INITIAL RECOMMENDATION OF THE DOWNTOWN DESIGN REVIEW BOARD

Project Number: 3009932

Address: 2700 Elliott Ave.

Date of Meeting: Tuesday, May 10, 2011

South Elevation Along Cedar St.

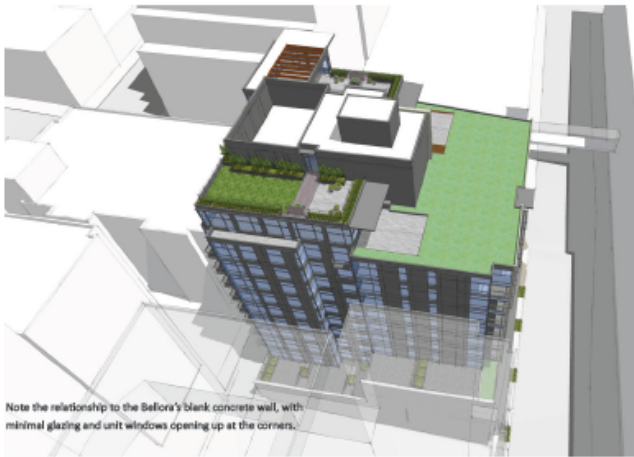
The Board observed that the Cedar St. façade was successful and requested that the Elliott Ave. façade be further designed to reflect and relate better to the one on Cedar St. The Cedar St. façade has a “frame” expressing a base which should be more closely approximated on Elliott Ave. It stated that Cedar St. façade “wants to” wrap around the corner. And while the sharp angularity of the bay window element is OK, it needs to be deeper to be more obvious.

West Elevation along Elliott Ave. and Building Details

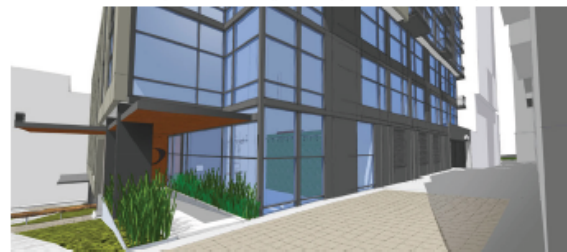
- Is the landscape near the pedestrian entry a forest or a grove? What is the landscape design intent there?
- The pedestrian entry point at the corner of Cedar St. and the alley could pose a safety issue as there is much traffic and there may be a tendency to stop or slow at the sidewalk, not at a building entry point accessing the alley north of the property corner and sidewalk.

The relationship between the alley and the building, especially the pedestrian entry element, caused the Board some concern over the interaction of pedestrians and automobiles. It requested that further work be done on this element, especially on ways to insure pedestrian safety exiting the building.
